ITEM NO. 16 - CHANGE 01
 516 Package 4
 Addendum No. 2

Muskegon Area
 Career Tech Center
MAISD / MCC
 Muskegon Michigan

HYDRONIC & NATURAL GAS PIPING PLAN

412

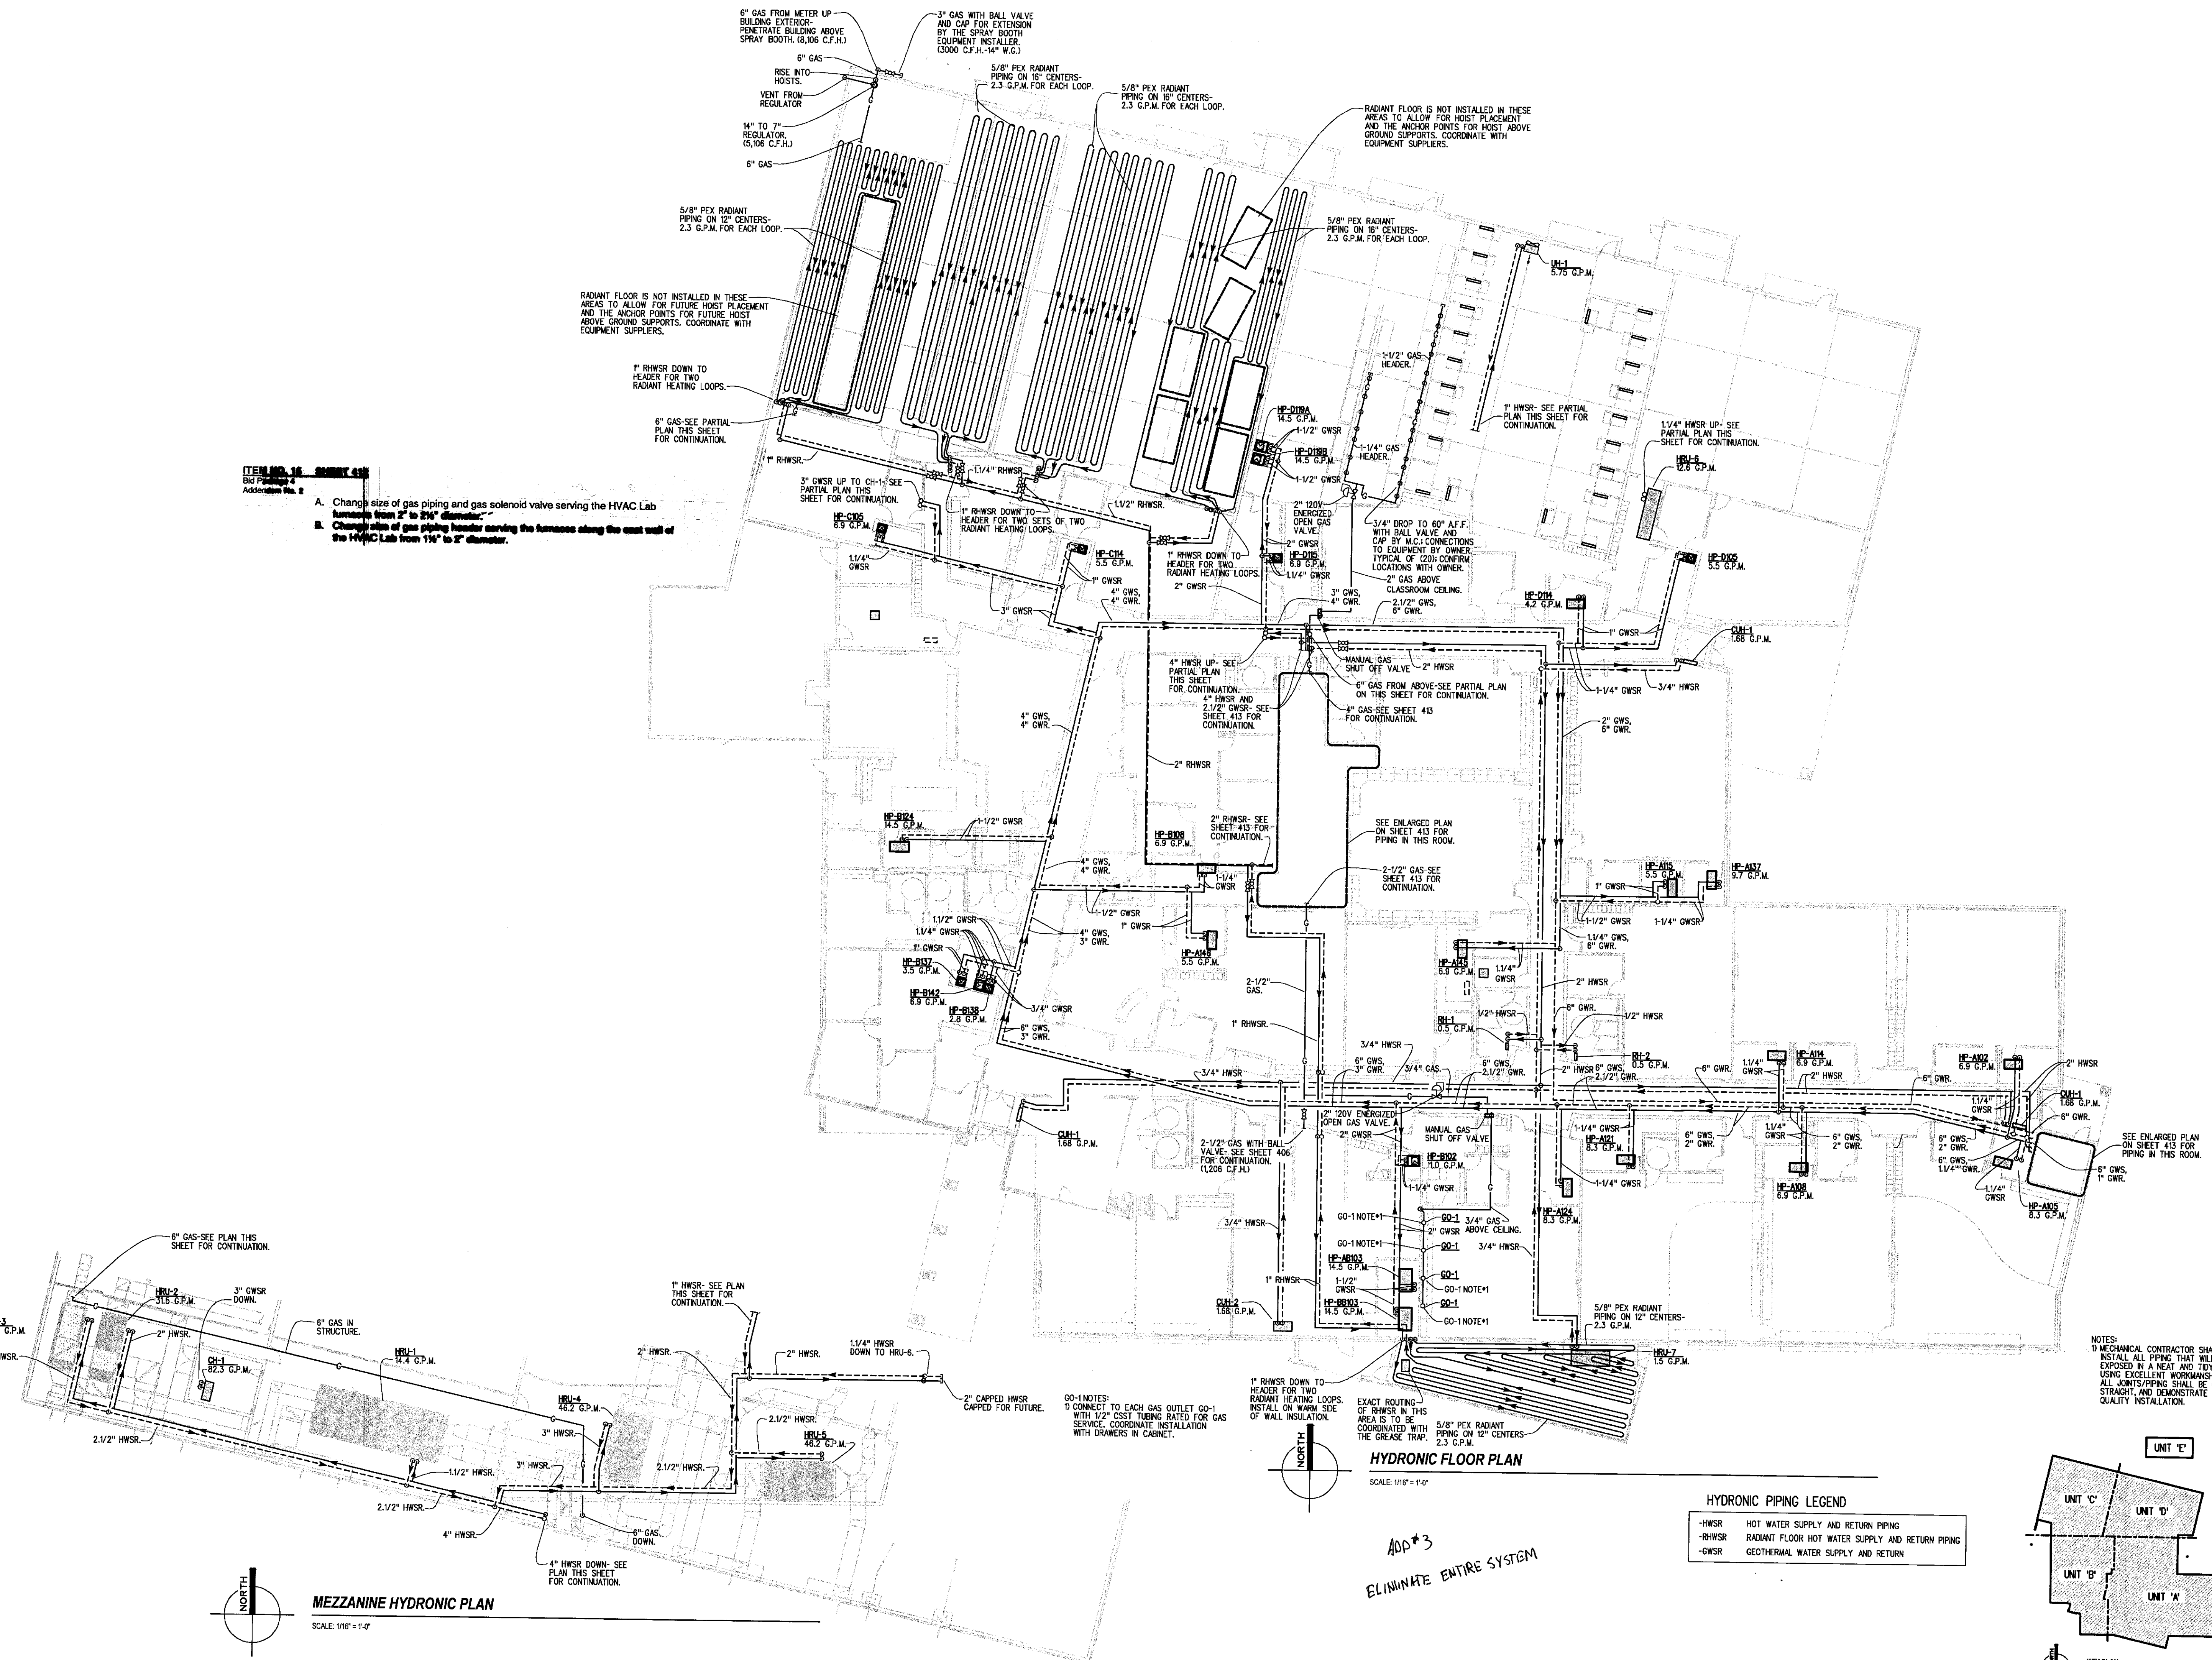
ADD #3
 ELIMINATE ENTIRE SYSTEM

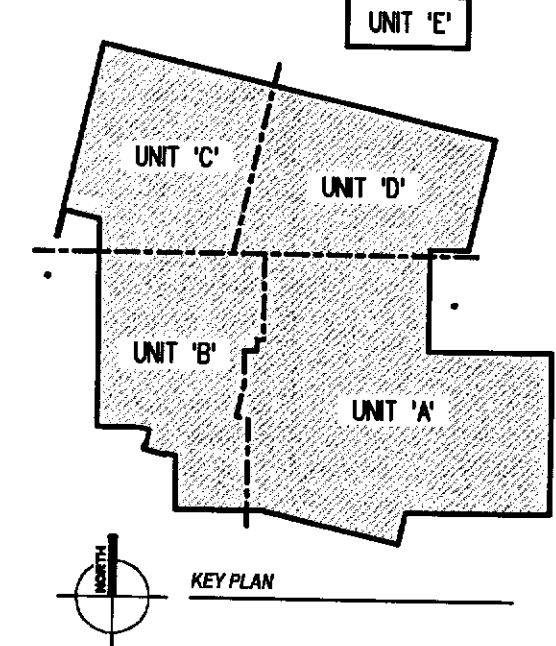
A. Change size of gas piping and gas solenoid valve serving the HVAC Lab furnace from 2" to 2 1/2" diameter.
 B. Change size of gas piping header serving the furnaces along the east wall of the HVAC Lab from 1 1/4" to 2" diameter.
